**KNOXVILLE/KNOX COUNTY METROPOLITAN PLANNING COMMISSION  
CITY OF KNOXVILLE CLOSURE OF PUBLIC RIGHT-OF-WAY**

▶ **FILE #:** 8-D-15-AC

▶ **RIGHT-OF-WAY TO BE CLOSED:** Unnamed alley

▶ **LOCATION:** Between Thirteenth Street and western terminus

**8-D-15-AC  
CLOSURE OF PUBLIC RIGHT OF WAY**

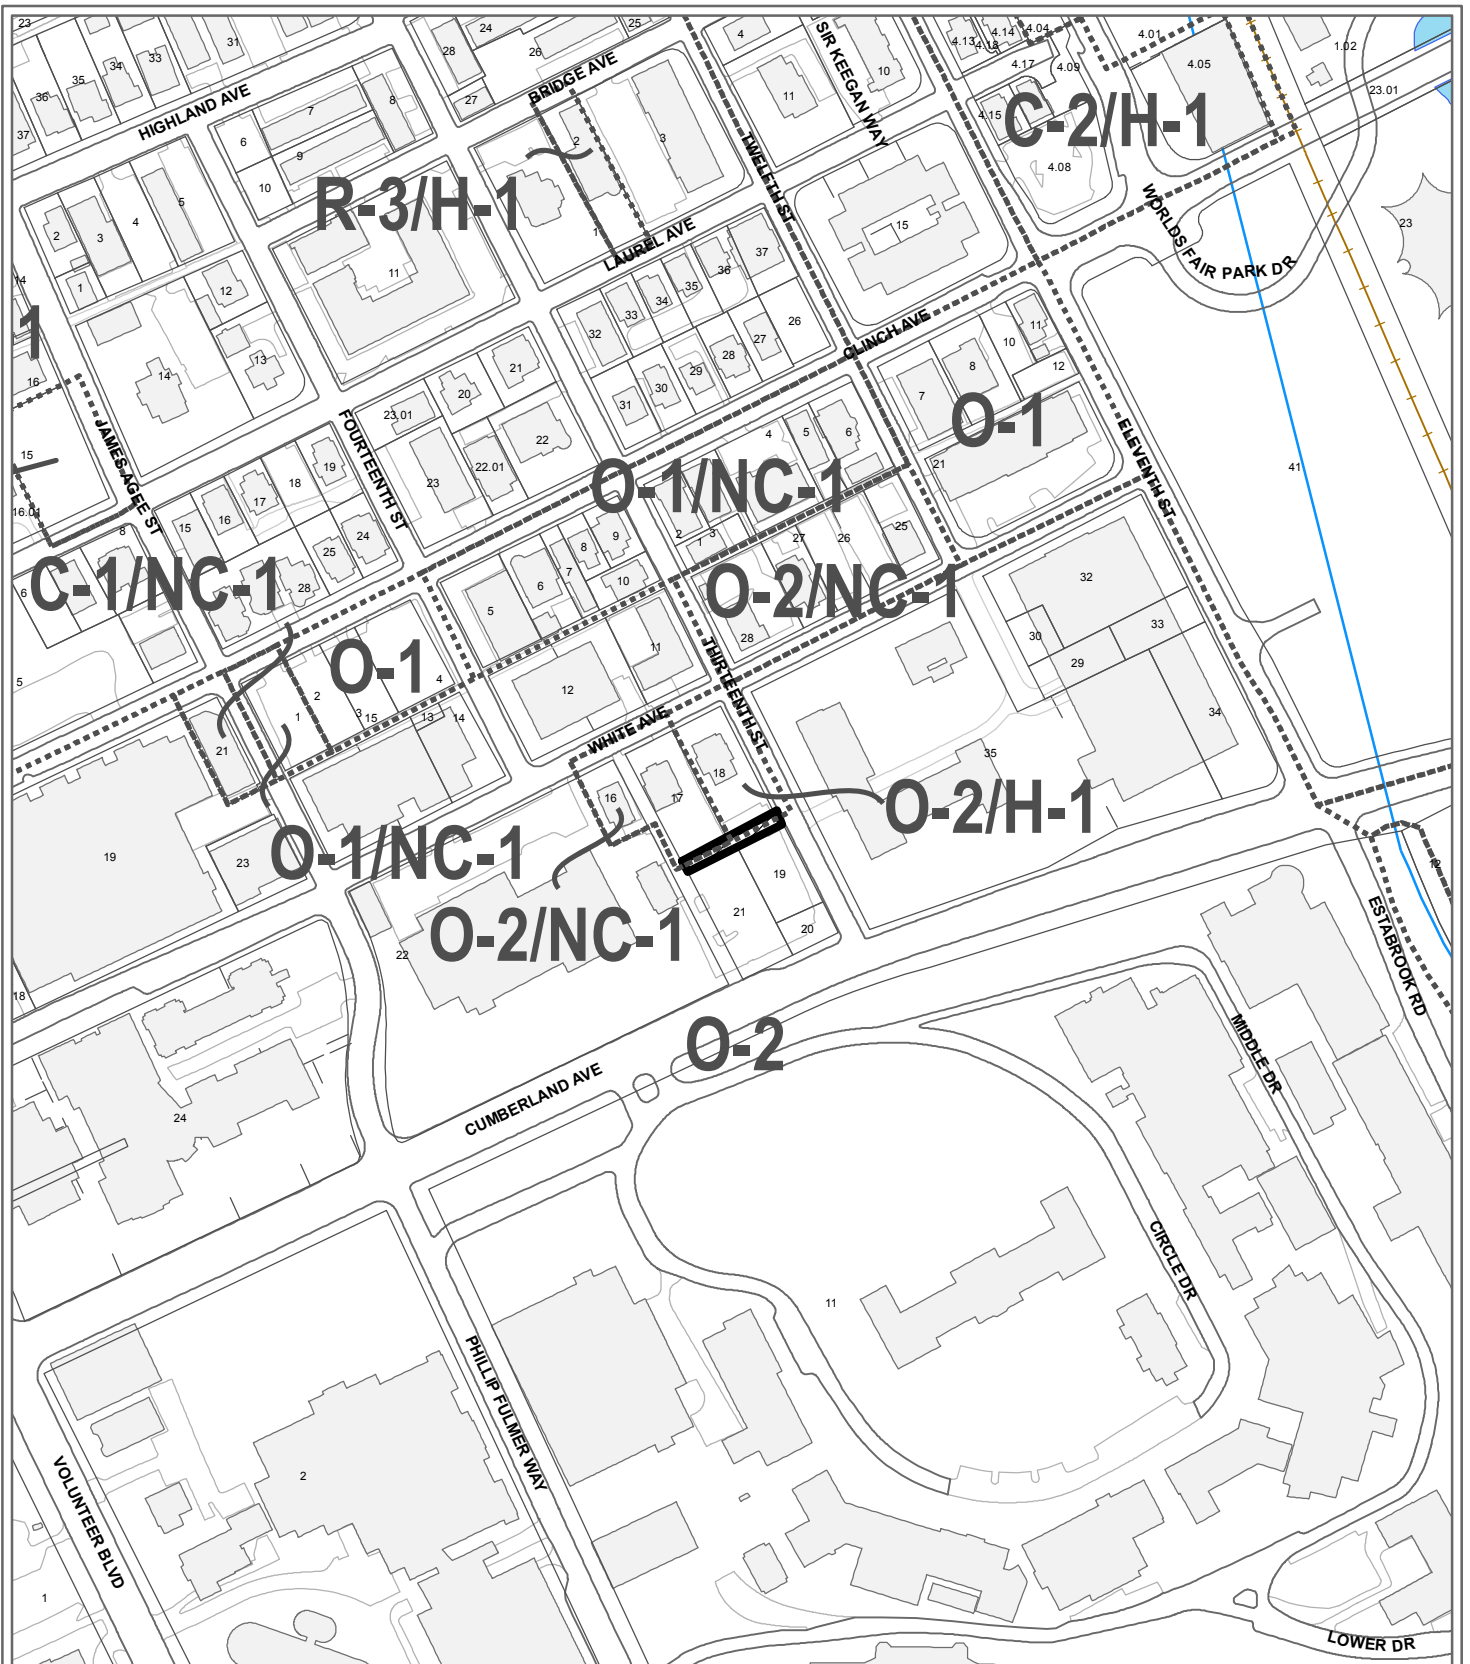
This paper alley is completely covered by a surface parking lot and is not needed for access to any parcels.

▶ **RECOMMEND** that City Council **APPROVE** the closure of the unnamed alley, as requested, subject to any required easements.

**File No. 8-D-15-AC Un-named Alley Closure (Sewer)**

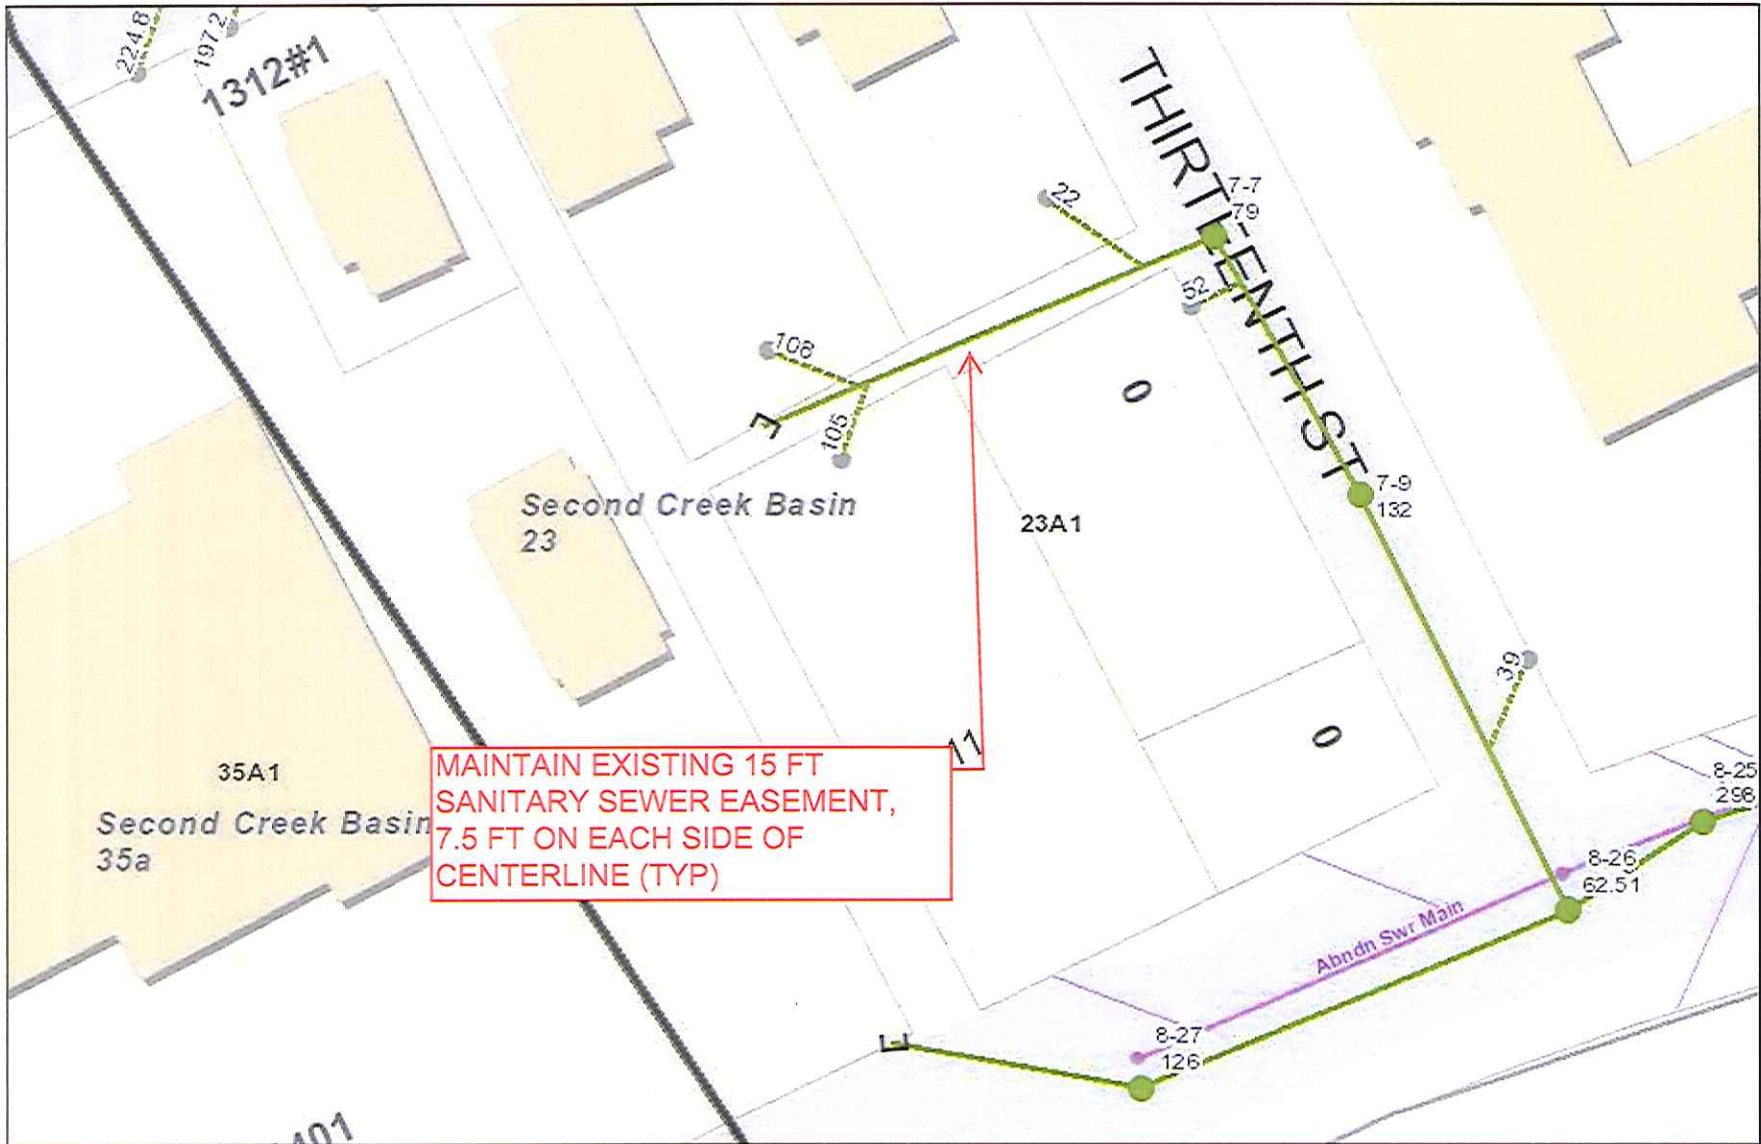
We have reviewed our records and find that we have existing utility facilities located within the subject right-of-way. The approximate location of these facilities is indicated on the enclosed prints. However, KUB does not release and hereby retains all easements and rights for existing utility facilities, whether or not shown on these prints.

Should this right-of-way be closed, KUB will require the following permanent easement for its utility facility.

Sewer – 7.5 feet on each side of the centerline of the wastewater line, 15 feet total width

MAINTAIN EXISTING 15 FT  
SANITARY SEWER EASEMENT,  
7.5 FT ON EACH SIDE OF  
CENTERLINE (TYP)

So long as these conditions are met, KUB has no objection to the closure of this right-of-way. If you have any questions regarding this matter, please call me at (865) 558-2291.
